HWY. No. 2LOCATION Failure of Embankment4 km W of WardsvilleNo of PAGES - 1

**Re: Inspection of Highway 2 Embankment  
4 km West of Wardsville  
Highway 2, District 32, Chatham**

Re: Restoration of Embankment  
Hwy. 2, 4 km West of Wardsville  
Contract No. 32-95-02 (WP 300-92-00)  
District 32, Chatham

Re: Restoration of Embankment (Stn. 14 + 567 to Stn. 14 + 625)  
W.P. 300-92-00, Highway 2, District 32, Chatham

SECTION AT STA 14+598.5

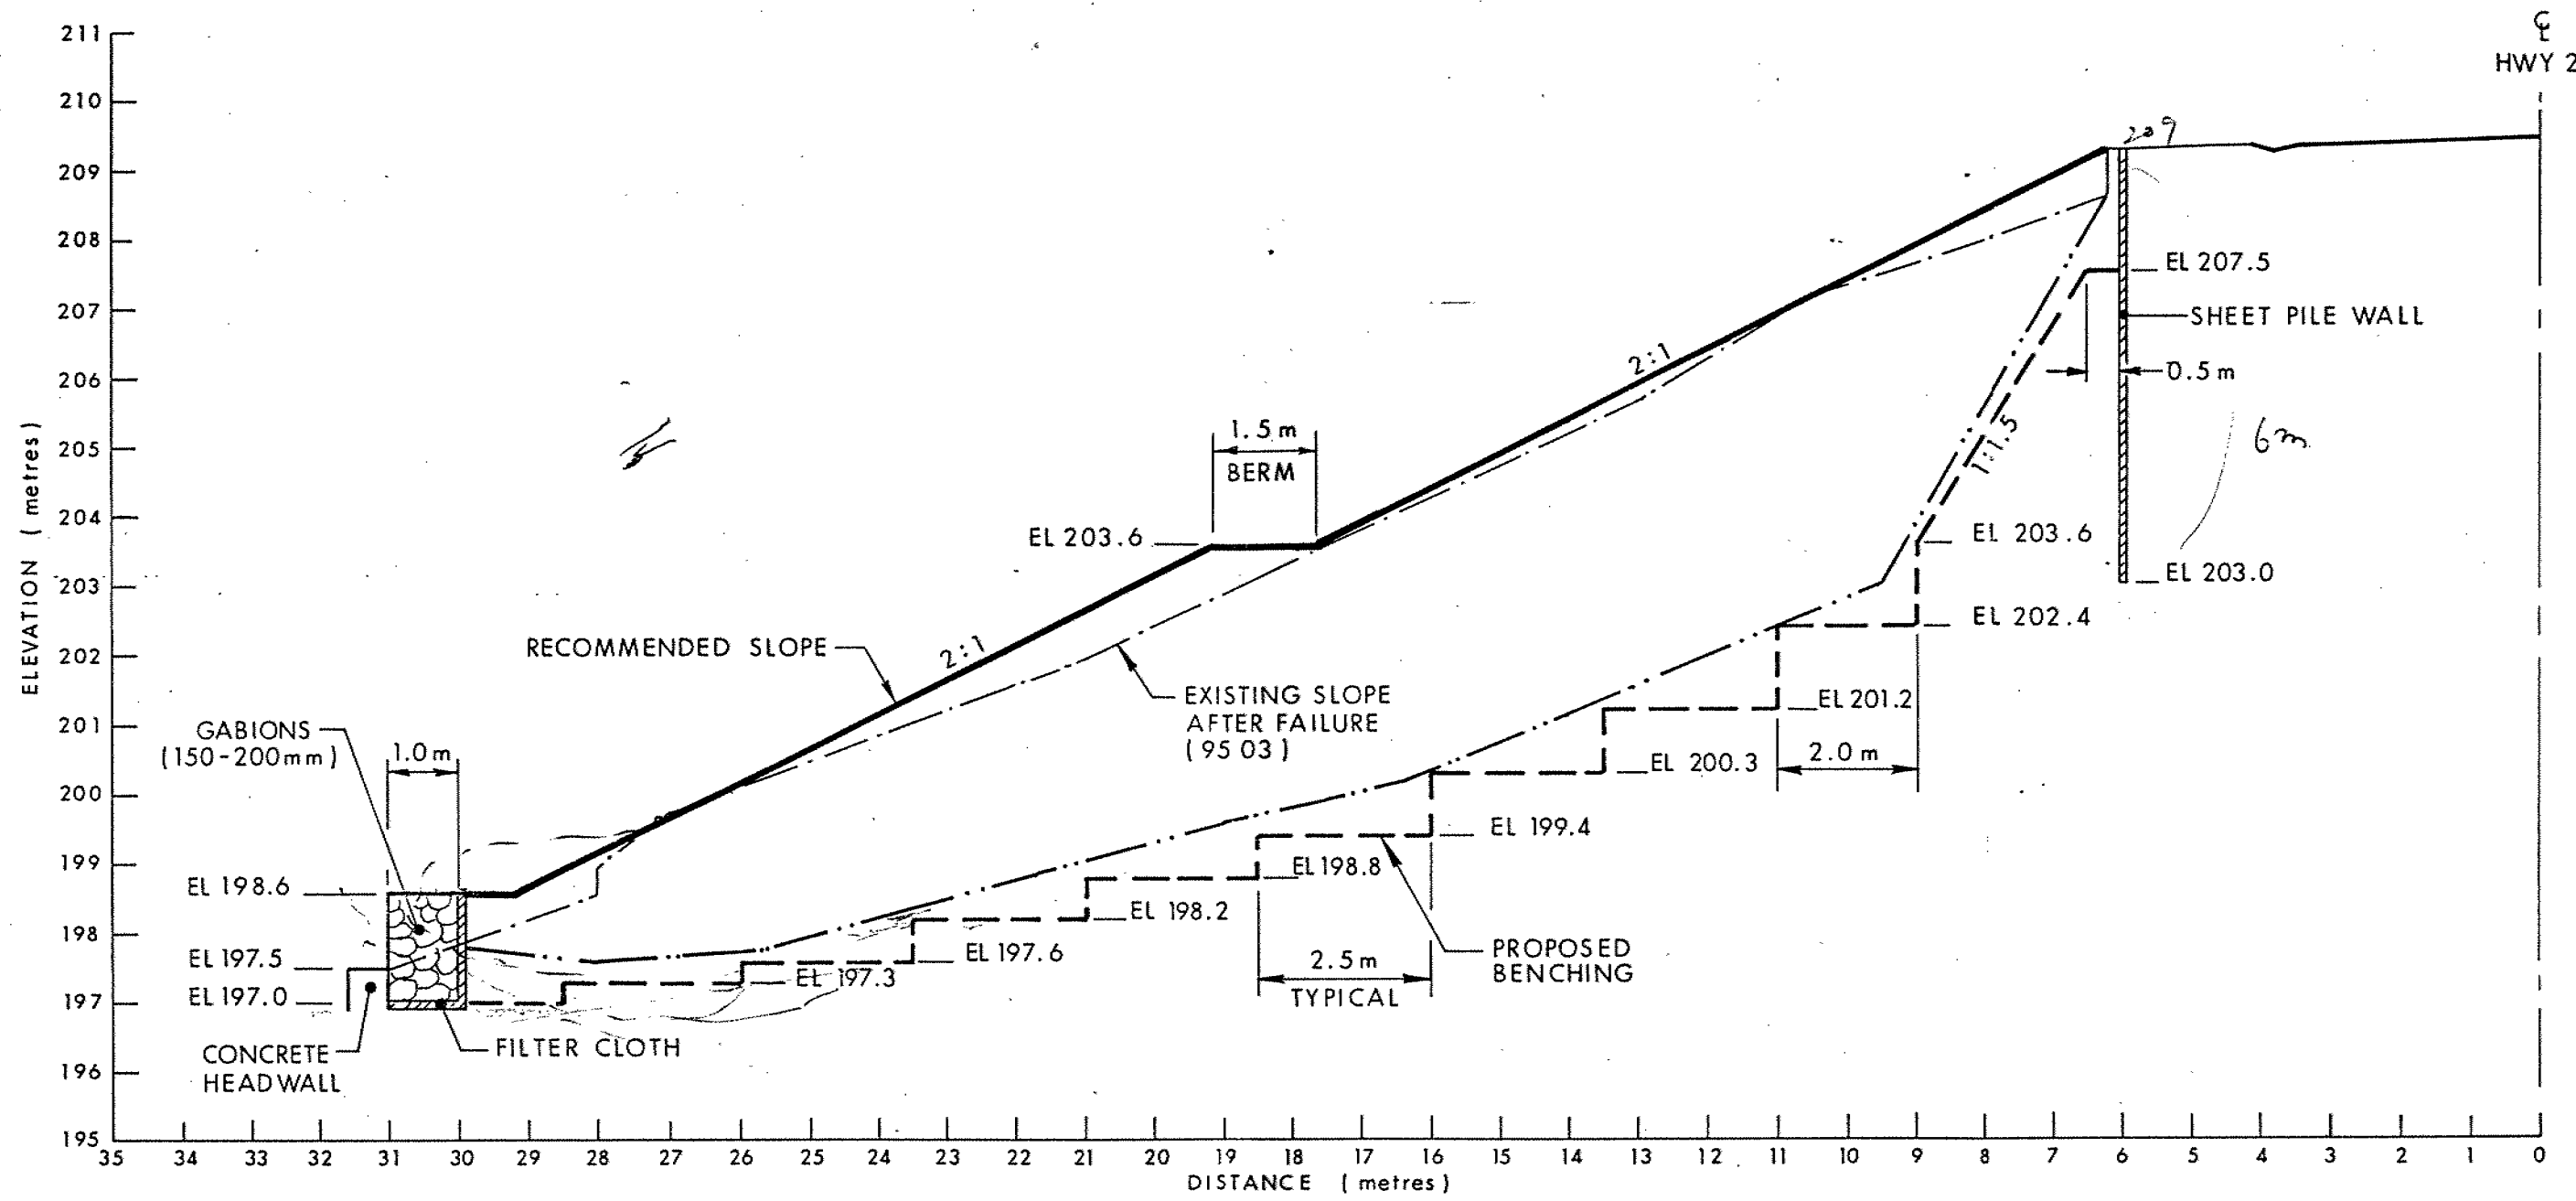
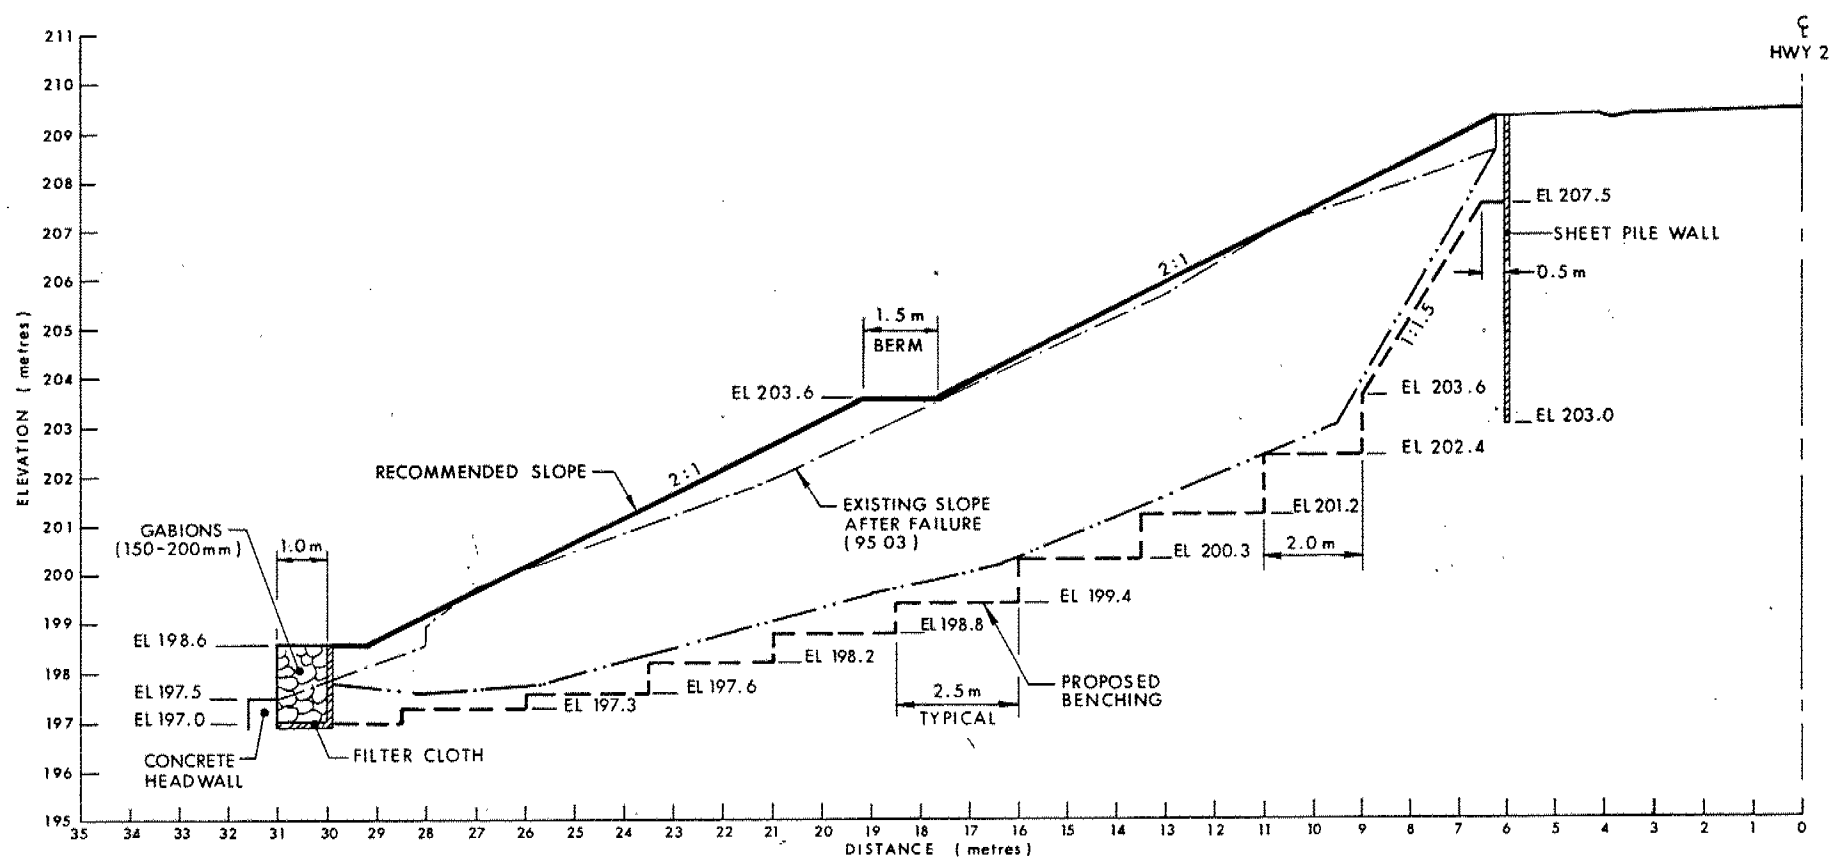
- 1) Are the drawings which accompanied your June 22, 1995 Memo available in digital (AutoCAD) format? If so can they be sent to me by e-mail? *No*
- 2) The granular fill specified on Figure 1 - what type of material should be specified (ie Granular A, Granular B, etc)? What is the lower limit of this material (bottom of gabion or subgrade)? *'Granular B' OK.*
- 3) Figures 3 and 4 show the gabion basket and filter cloth resting on subgrade, Figure 2 shows gabion installation above subgrade. Should figure 2 show the gabion placement on subgrade as well? *This should be as shown in Figure 2*

**Fig 1 - EMBANKMENT INSTABILITY**  
(BETWEEN STA 14+563 & 14+635 HWY 2 )

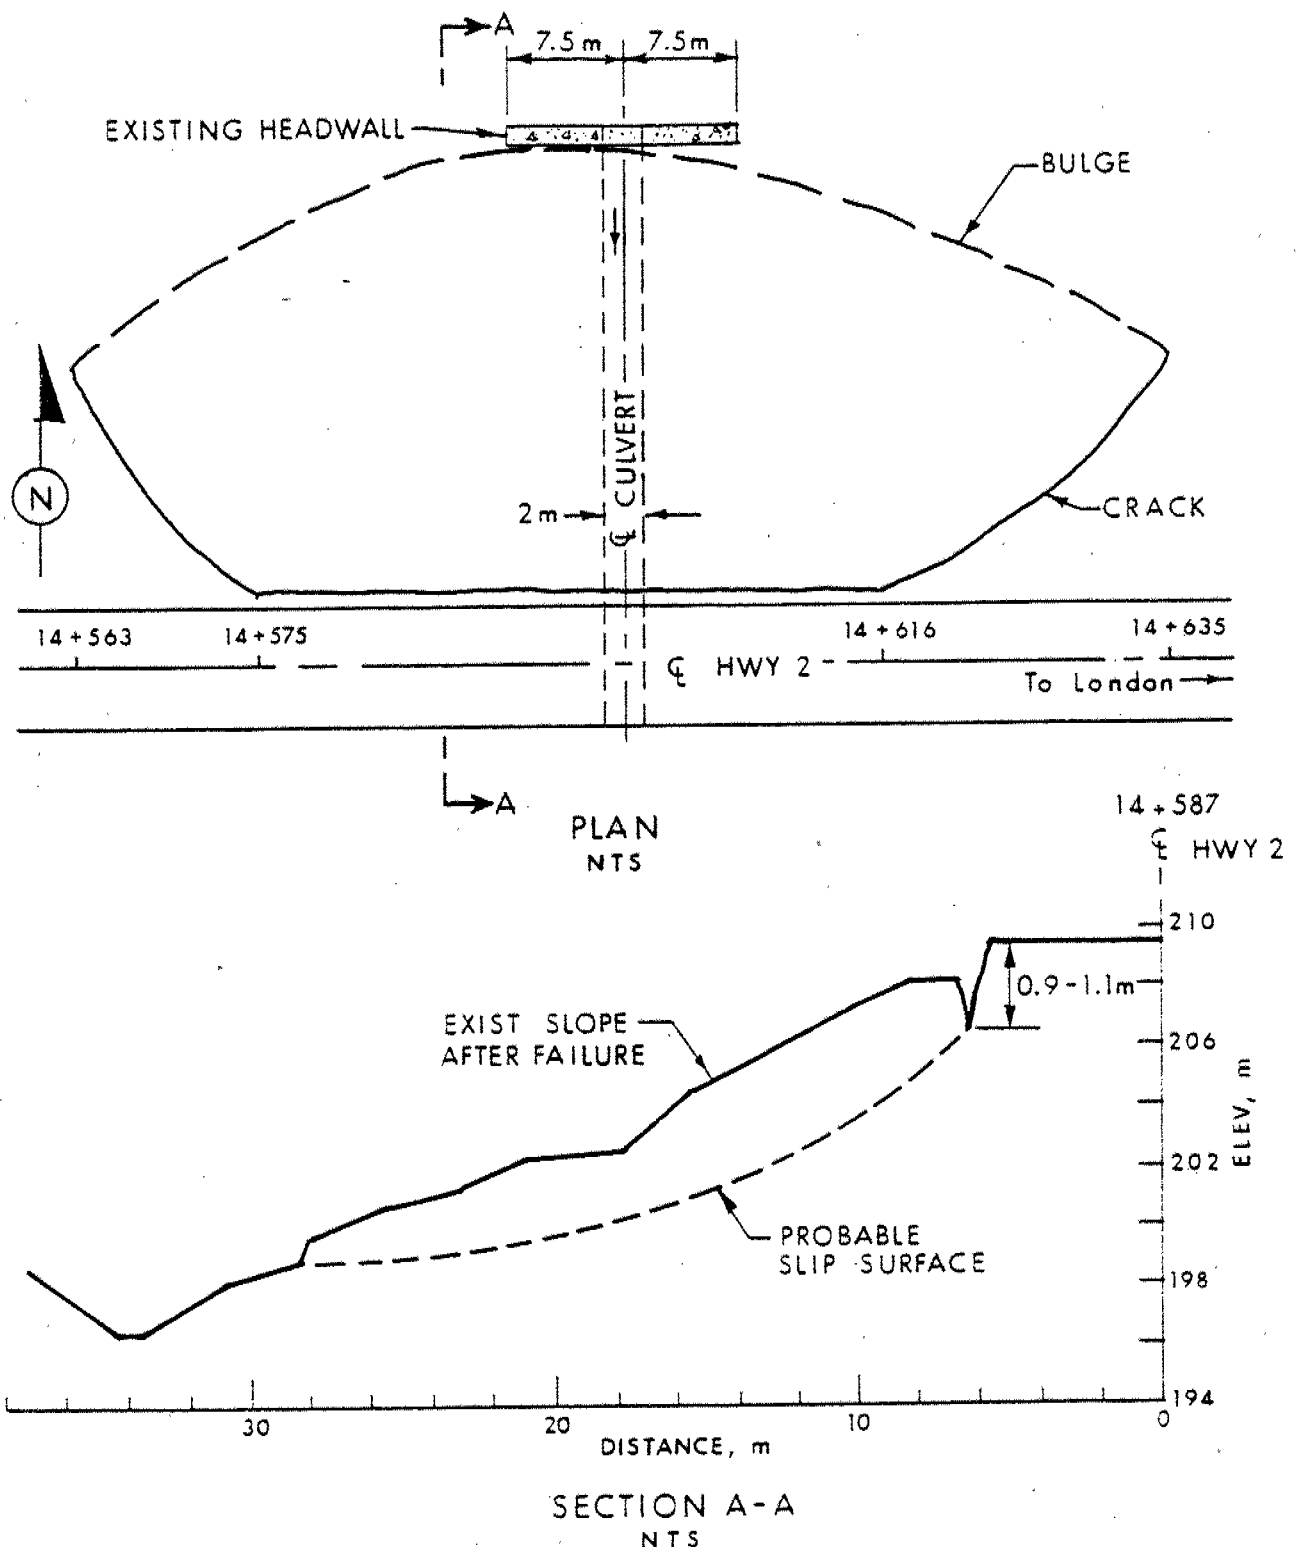
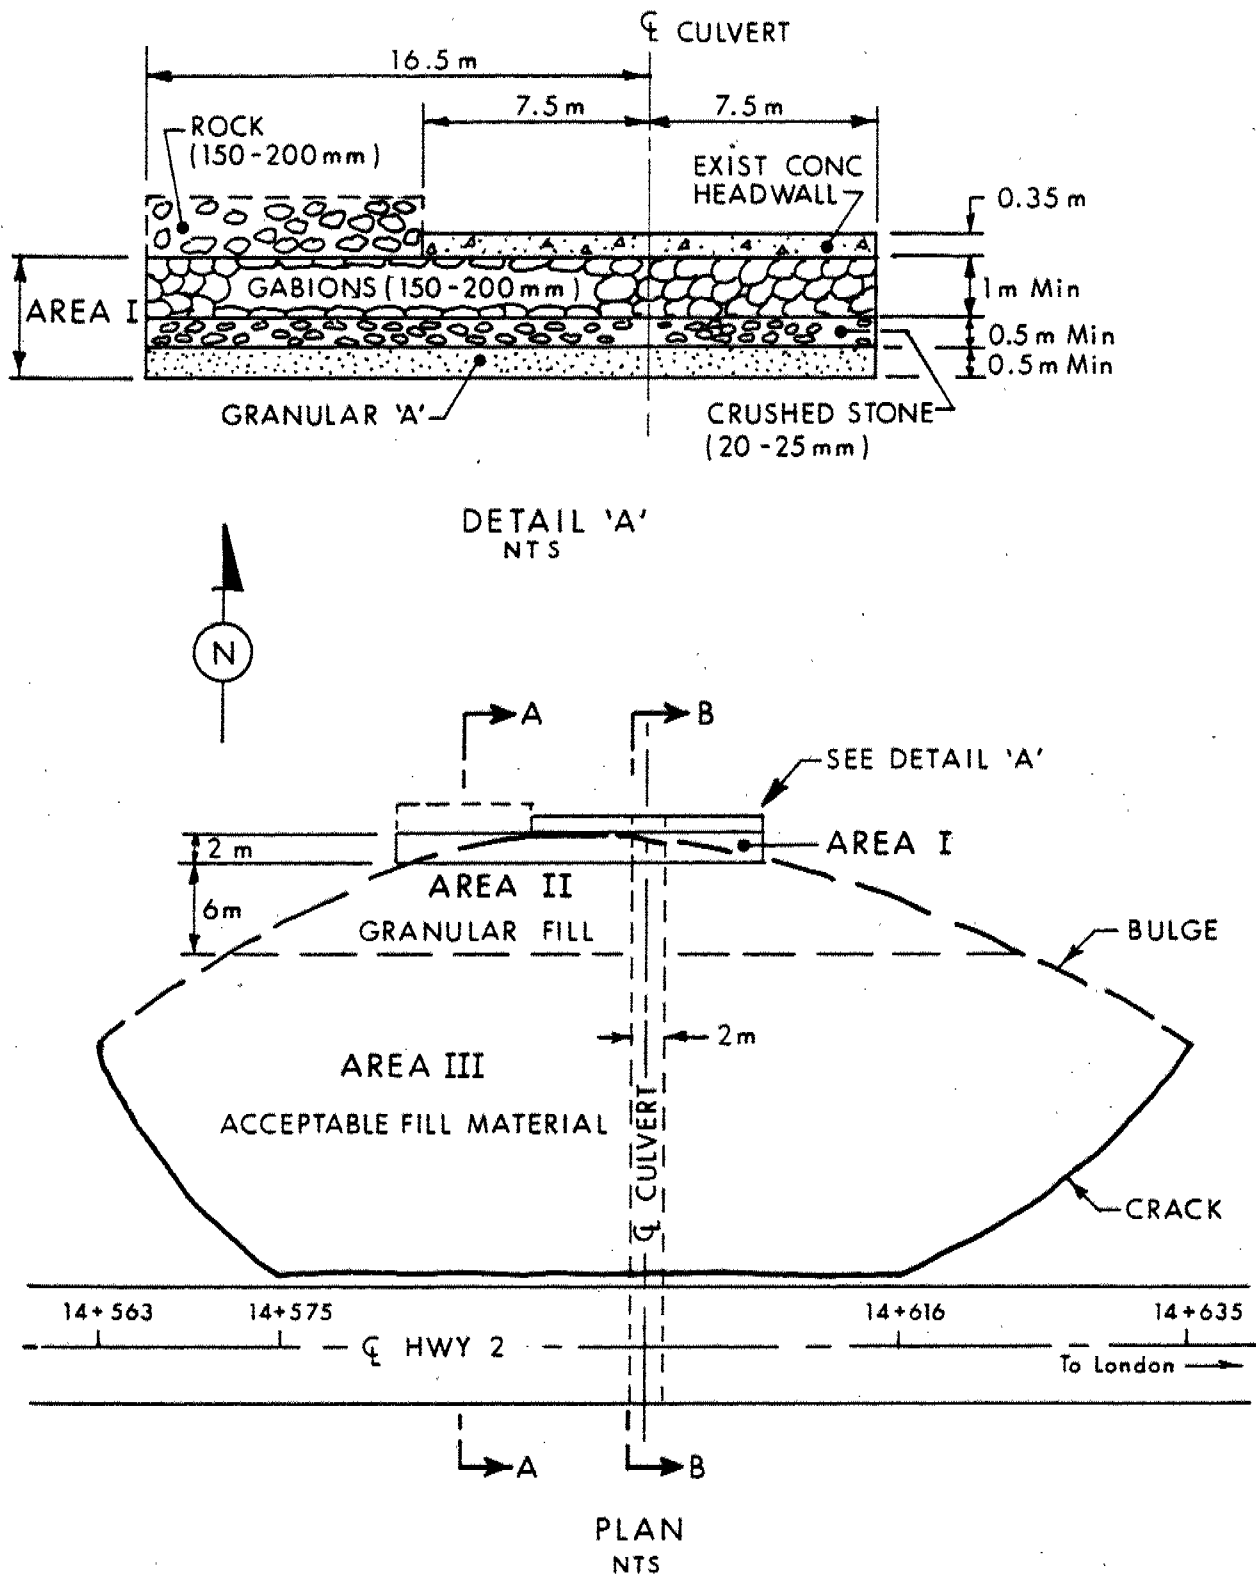
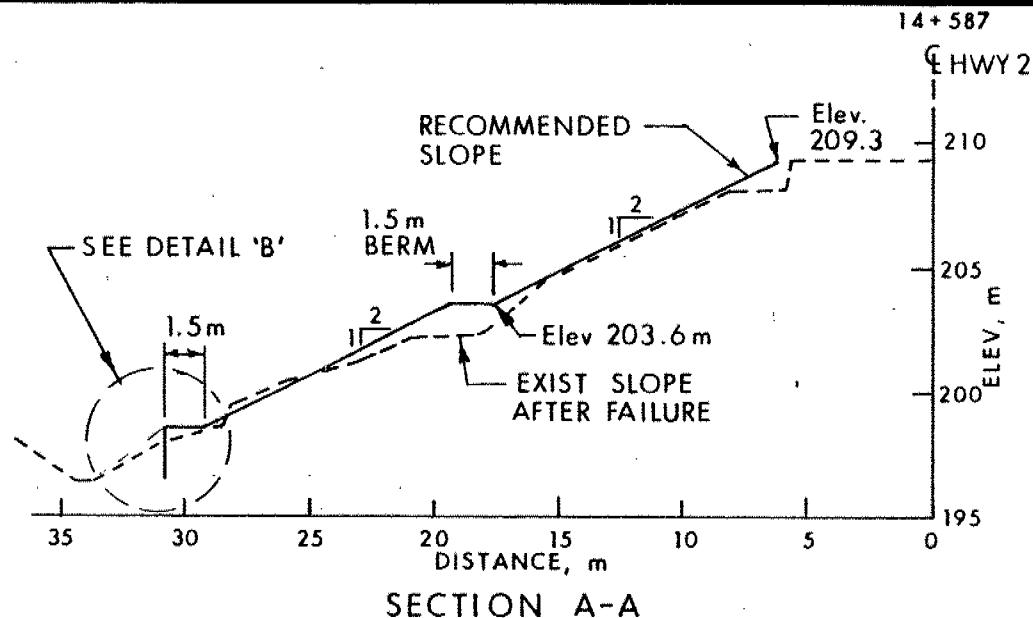
The surface crack adjacent to the guard rail extends to a distance of about 41 m, however, the failed area gradually spread to a distance of about 72 m near the middle of the embankment and narrows down to about 4.5 m at the toe. Surface cracks varying in width from a few millimetres to a maximum of 600 mm were observed. The failed portion is displaced by approximately 0.9 m to 1.1 m vertically and 0.3 m to 0.6 m horizontally. However, near the toe of the embankment, bulge of soil varying in thickness from a few millimetres to a maximum of about 300 mm was observed. The details of the failure are shown on Figure 1.

Based on the information gathered, it appears that the failure is confined to the fill itself and centred around the culvert location. The probable failure surface is shown on Figure 1 and it is expected to extends to a depth of 2.5 m to 3.0 m below the existing slope at the deepest location.

**Fig 2 - RESTORATION OF EMBANKMENT**

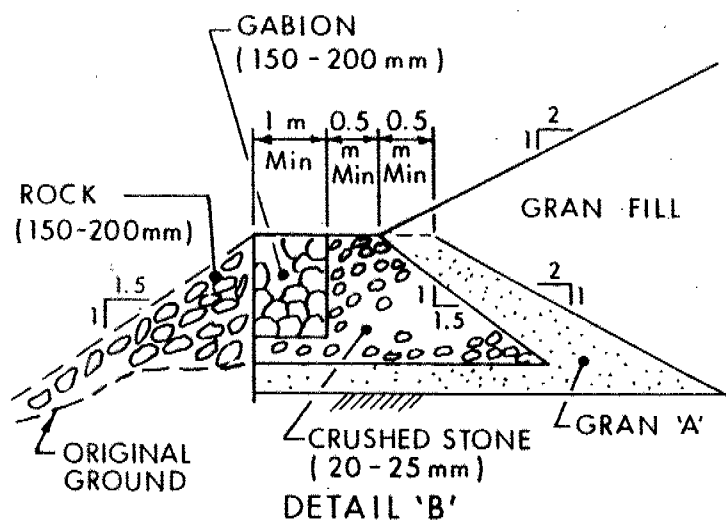
The recommended gabion adjoining the head wall should be placed at least 0.3 m to 0.4 m below ground level and extend to a height of 1.0 m (El. 198.6) above the head wall to accommodate 1.5 m wide berm around El. 203.6 (refer to Figure 2 & 3). However, near the crown of the culvert, depth of 0.3 m to 0.4 m into the ground may not be feasible and this may be reduced according to the availability of space.
